National Highways Authority of India

NHAI/PIU-PALM/HP/11016/12/Forest/2022-23/1236

Sub: Diversion of 7.1203 hectare of forest land for rehabilitation and up-gradation to Four Lane configuration & Strengthening of Sihuni to Rajol from Kms. 51/00 to 72/00 (Package-IIA) (Design Length 18.450 Kms) of NH-20 (New NH-154) of Pathankot-Mandi Section in the State of Himachal Pradesh within the jurisdiction of Nurpur, Dharamshala & Dalhousie Forest Divisions in District Kangra & Chamba (Online Proposal No. FP/HP/Road/152261/2021).

In this connection, it is submitted that the point-wise reply to the observations raised by GoI is furnished as under:-

LINEAR PLAN OF NH-154
 (KM 59+000 TO KM 63+000)

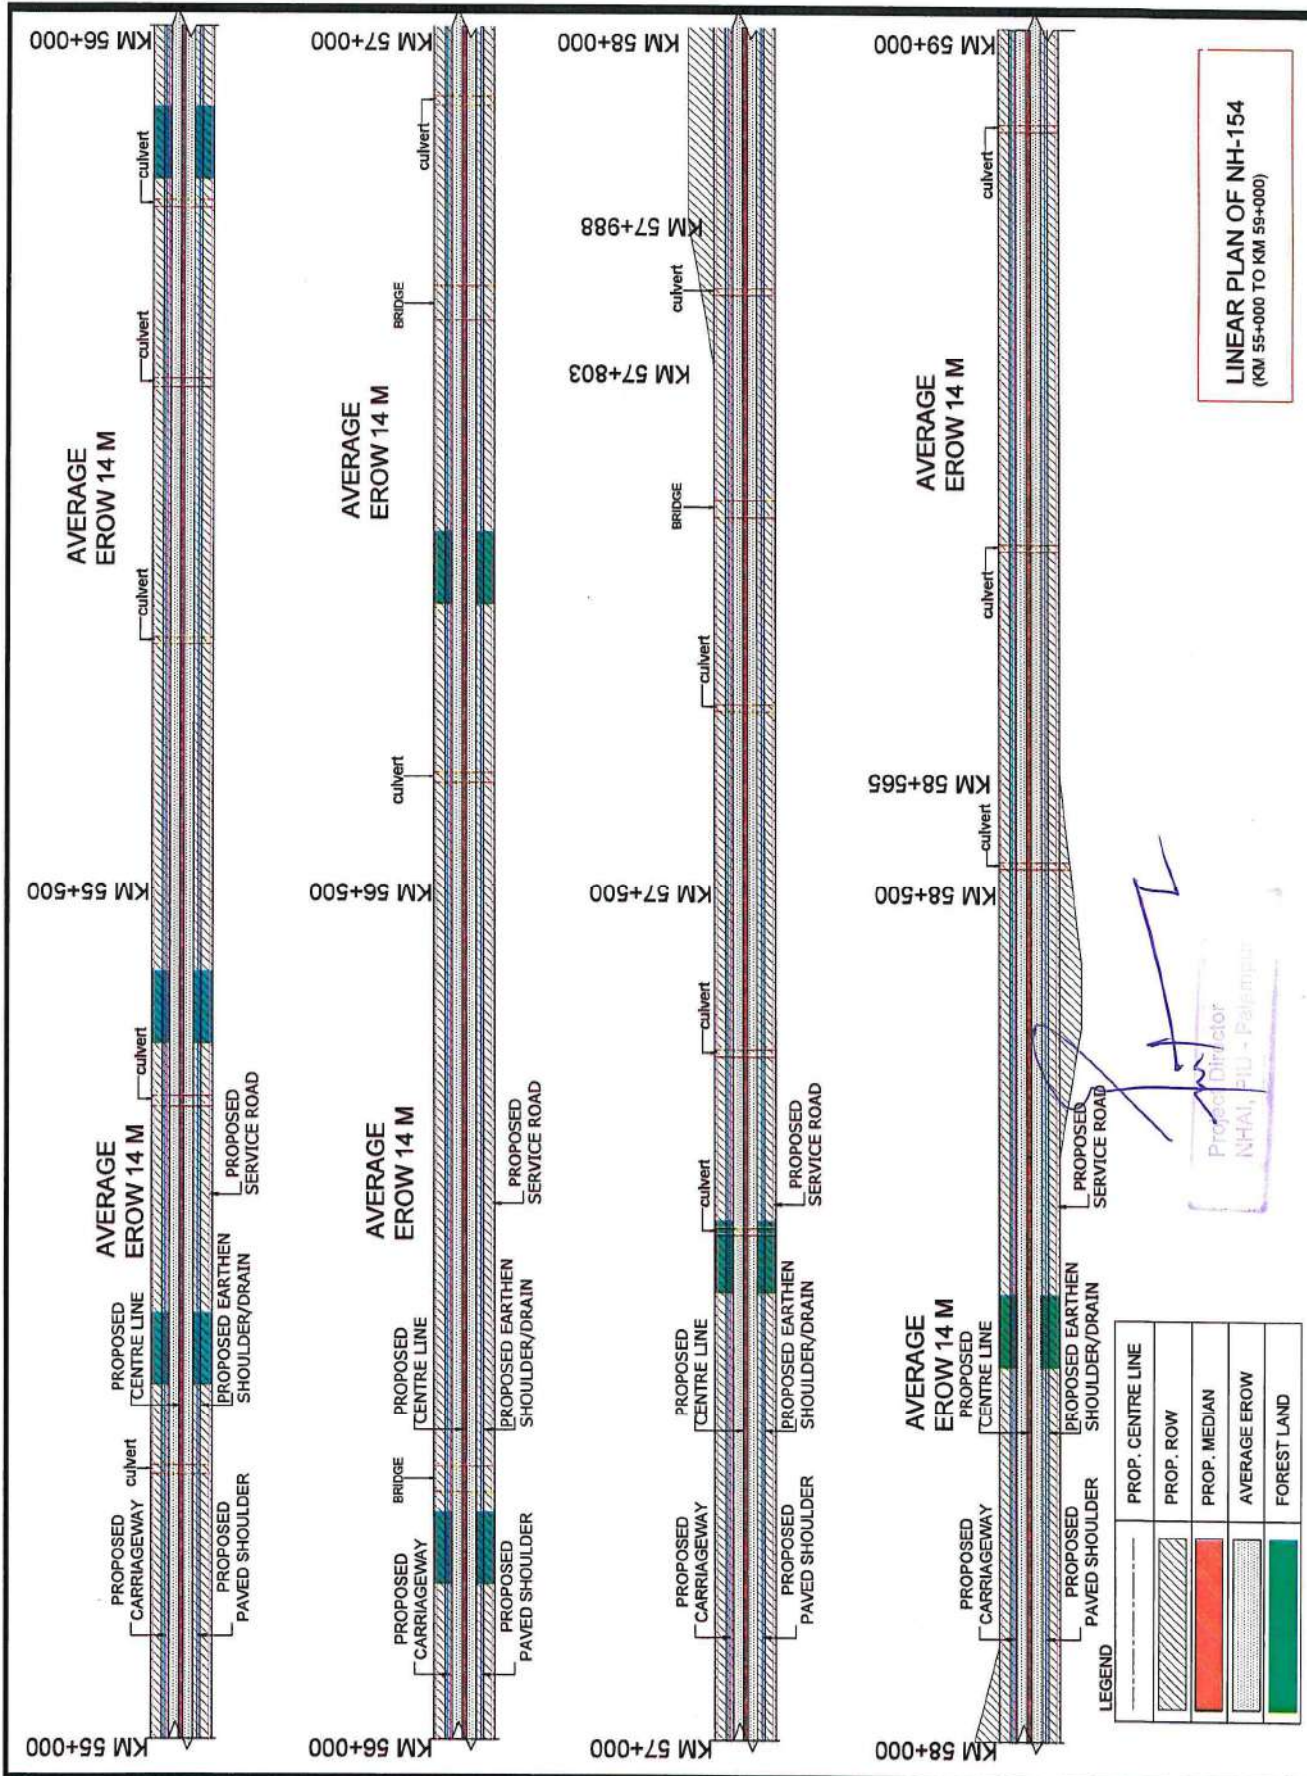
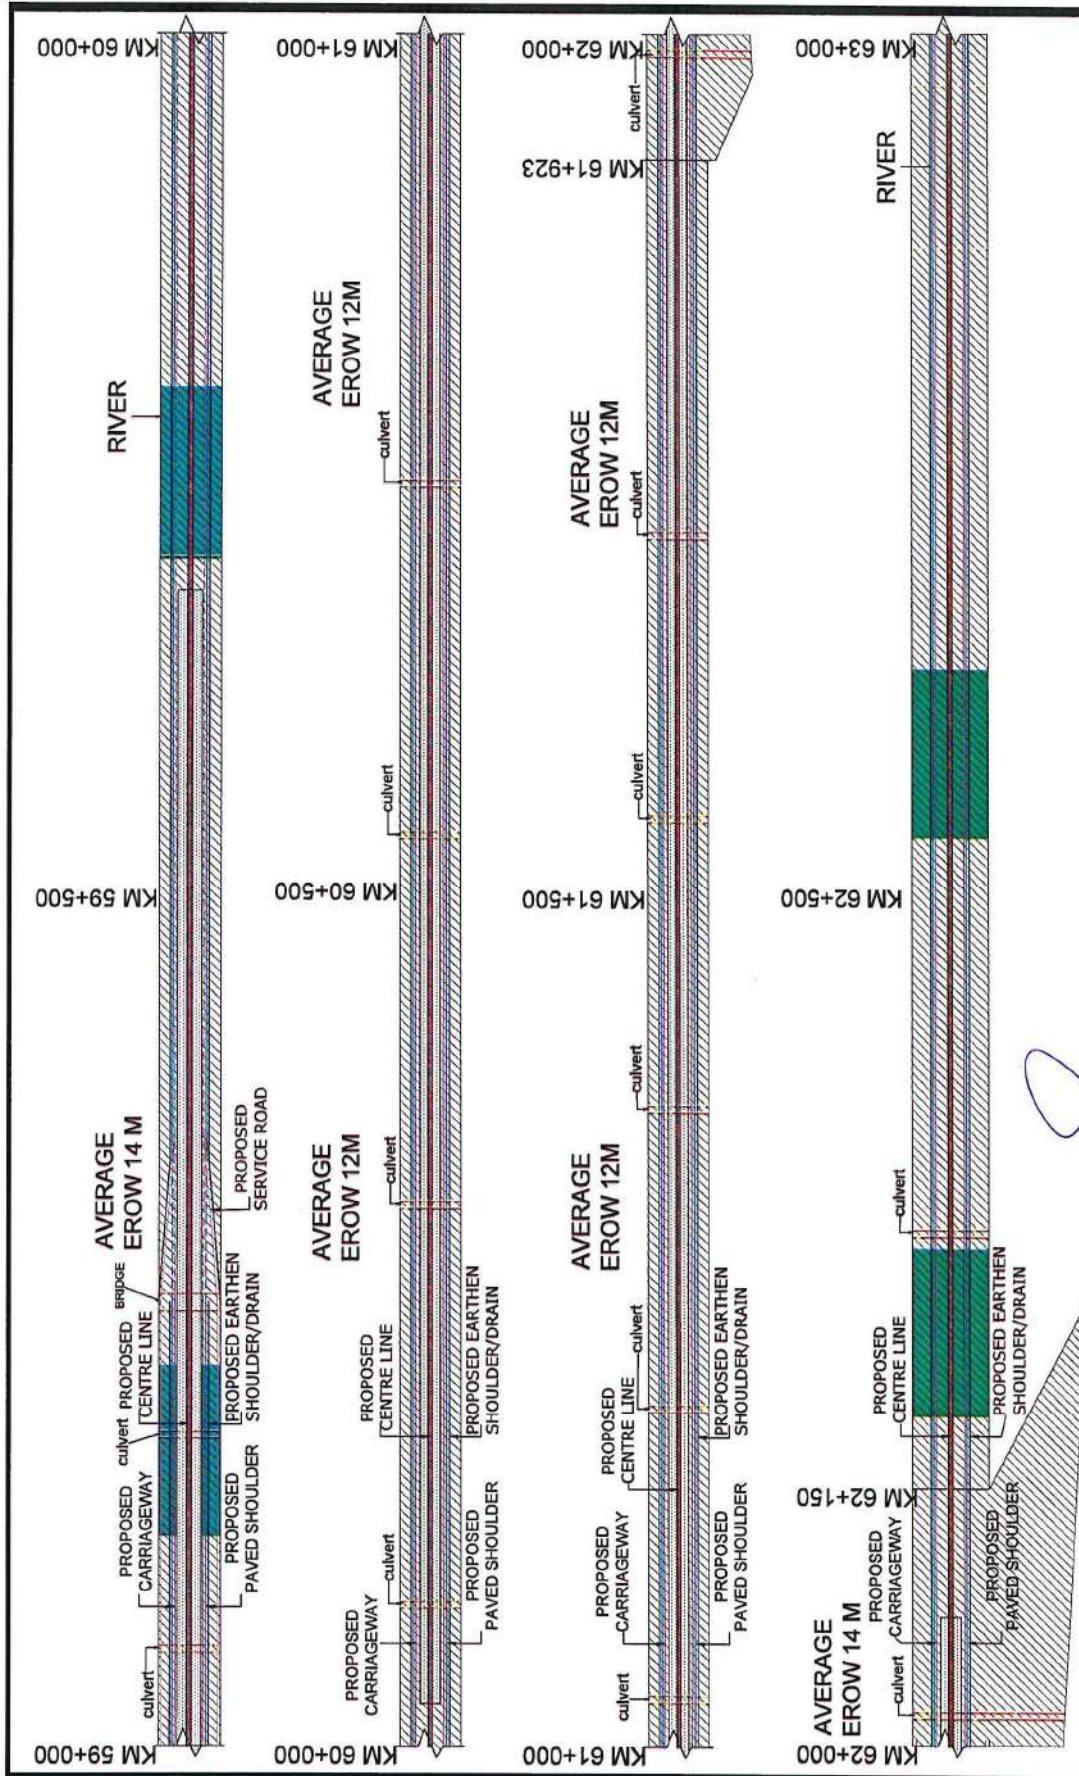
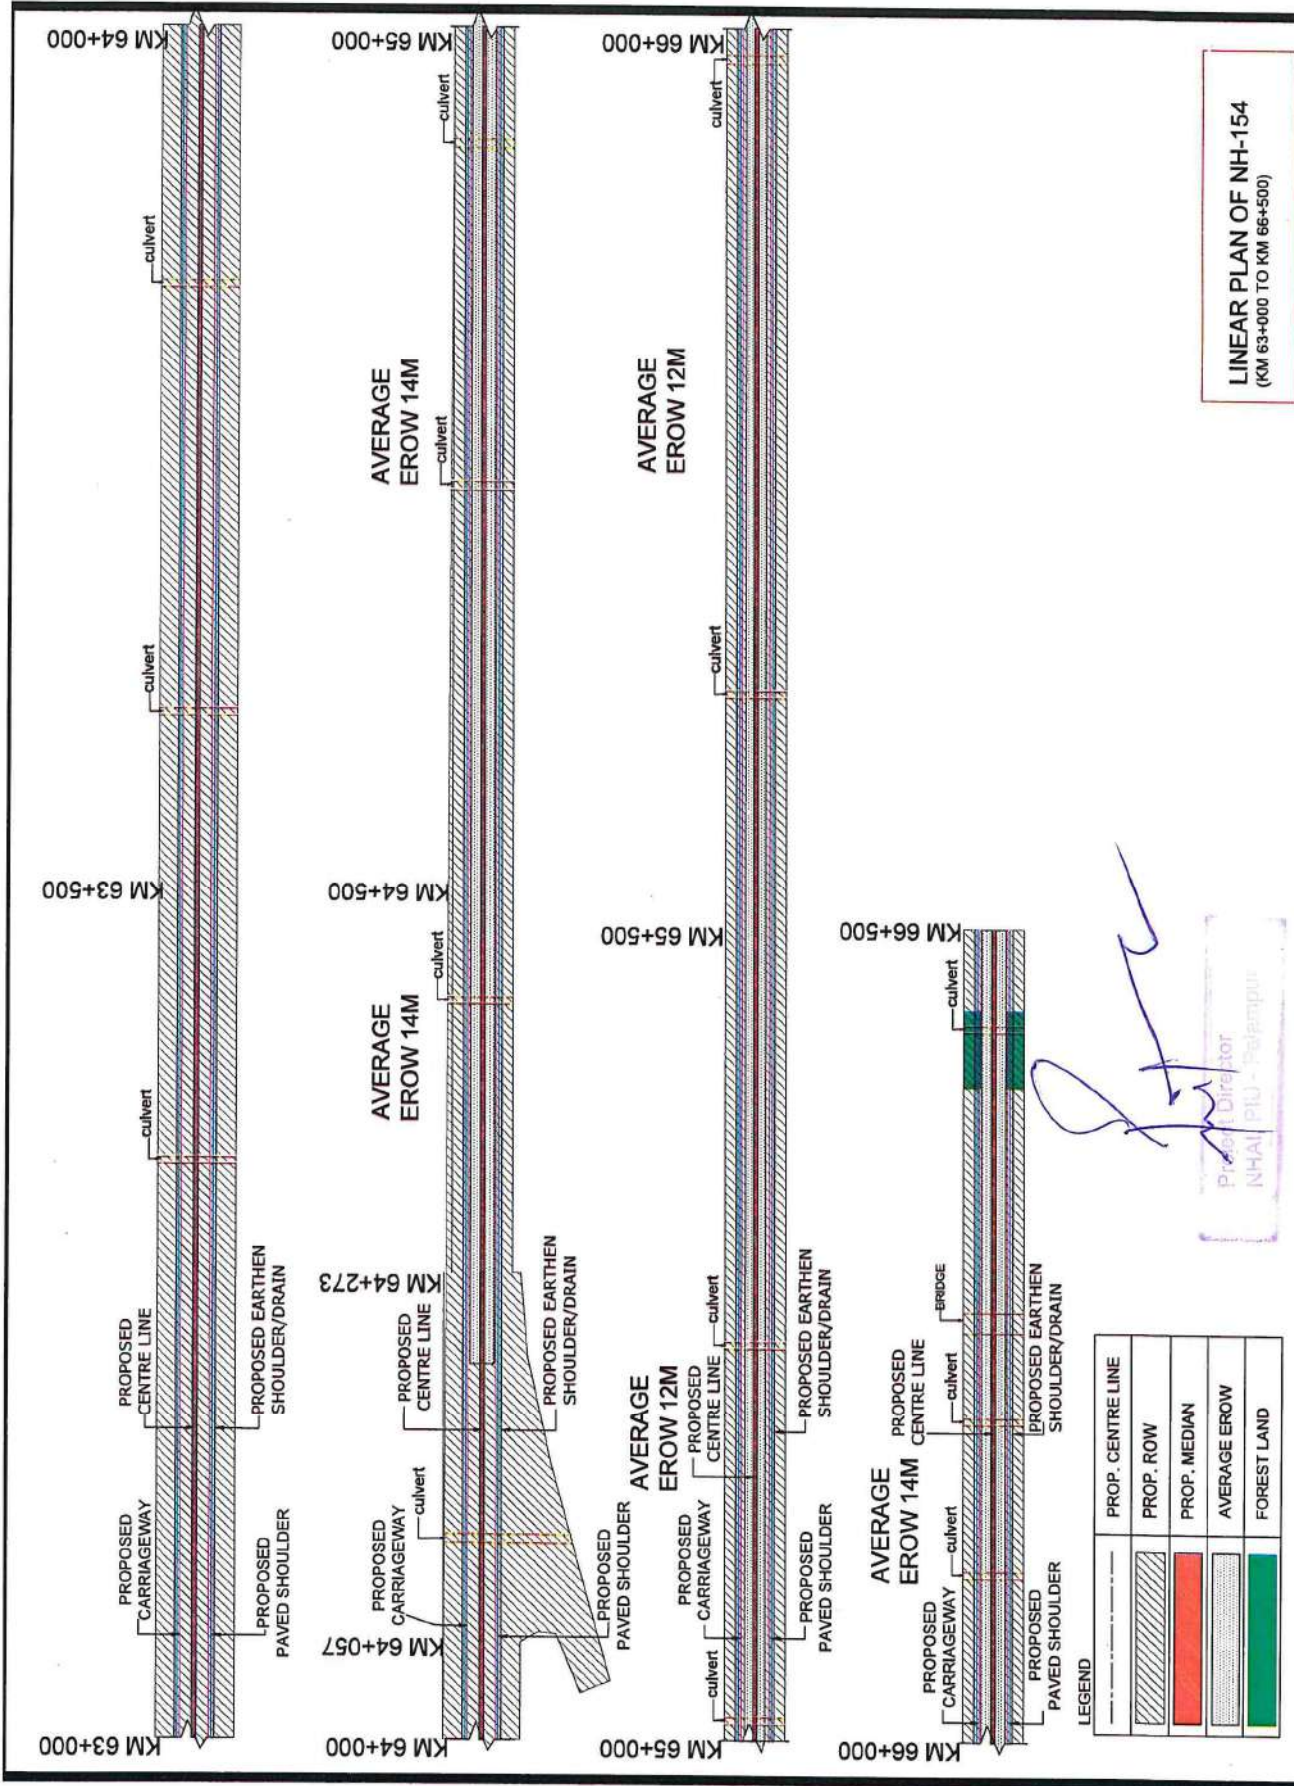
17. The necessary line plan has been prepared on the prescribed format and uploaded on the MoEF & CC Web Portal. The copy of the same is also enclosed herewith. Annexure -K
